## Product Change Notification

1. **ECR #:** 218869  
**Notification #:** 658

3. **Series:**  
• UMPS - UMPS ASSEMBLY

4. **Part #'s Affected**  
• UMPS-XX-XX.X-XX-V-X-X-XR

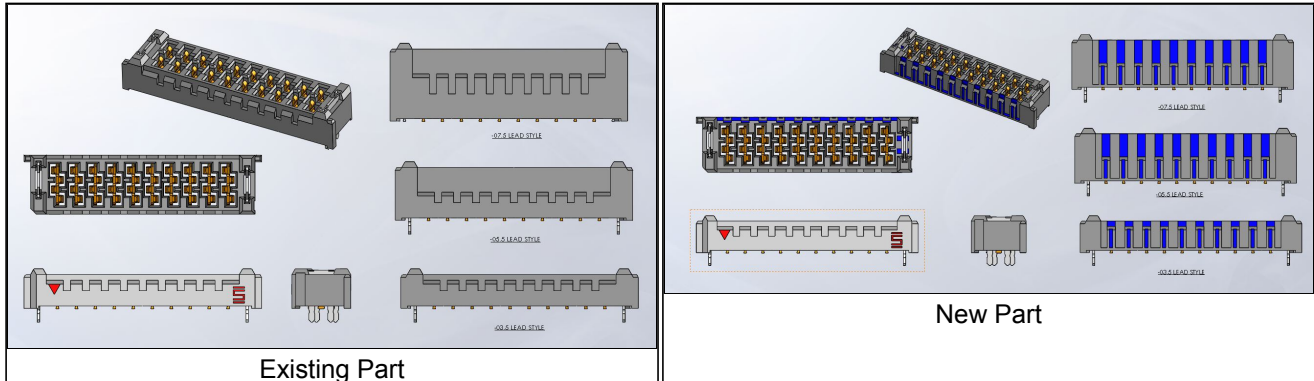
5. **Description of Change:**  
Change the outer void of side rib design and add void to right Weld tab hole.

6. **Method of Identifying Change**  
Visual inspection, see picture for the body changes highlighted in blue color.

7. **Reason for Change:**  
Change made to improve body knit line.
